1420 RIDGECREST DR. – After the Fact Approval of Windows

(H24-021-COA)

CITY OF HENDERSONVILLE - COMMUNITY DEVELOPMENT - HISTORIC PRESERVATION
COA STAFF REPORT

Previous window replaced with glass block window on left side of home. The trim has since been painted white.

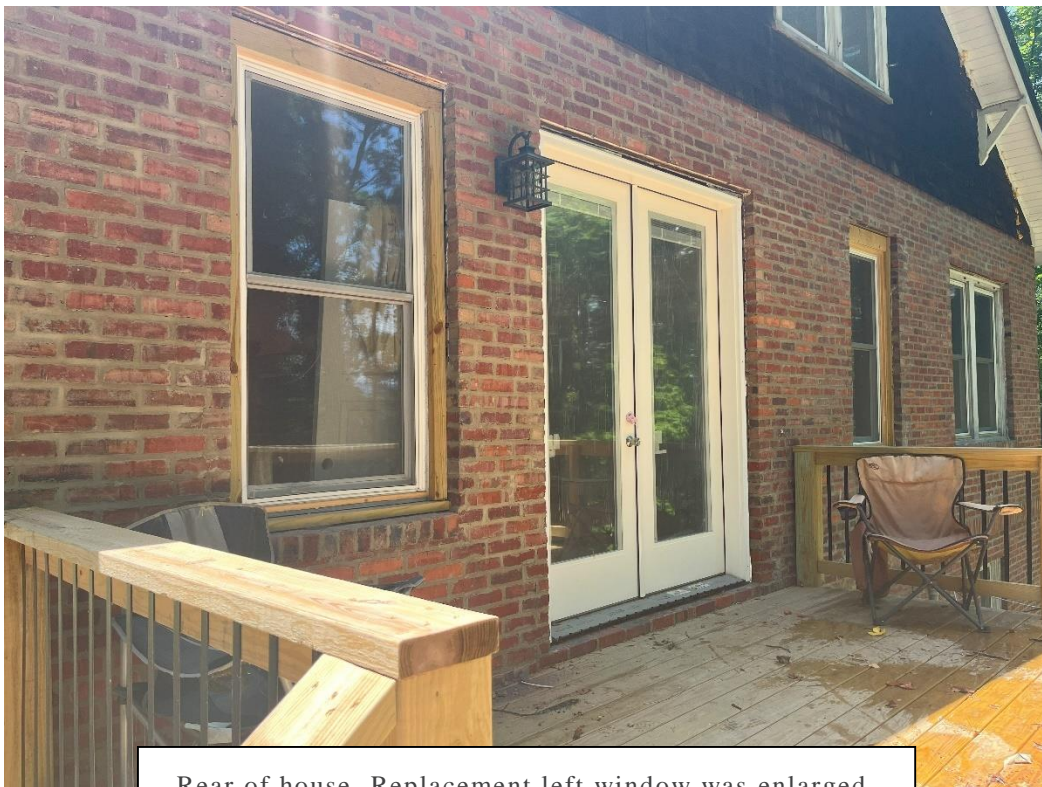
Left side of home with replacement windows.

Rear of house. Replacement left window was enlarged. Window to the right of the double doors replaced the spot previously occupied by the back door.

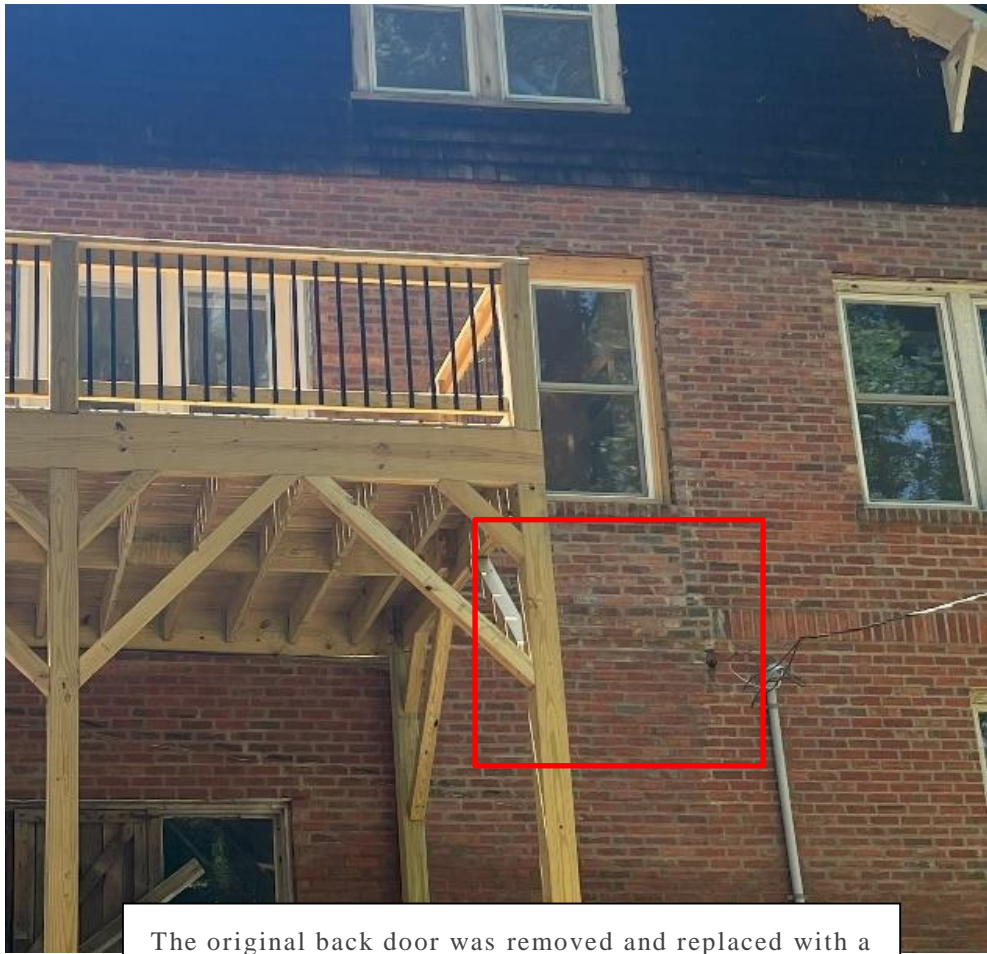
The original back door was removed and replaced with a window. Brick was used to fill in underneath the window.

Left window opening on rear of house was increased in size to allow for a larger window.
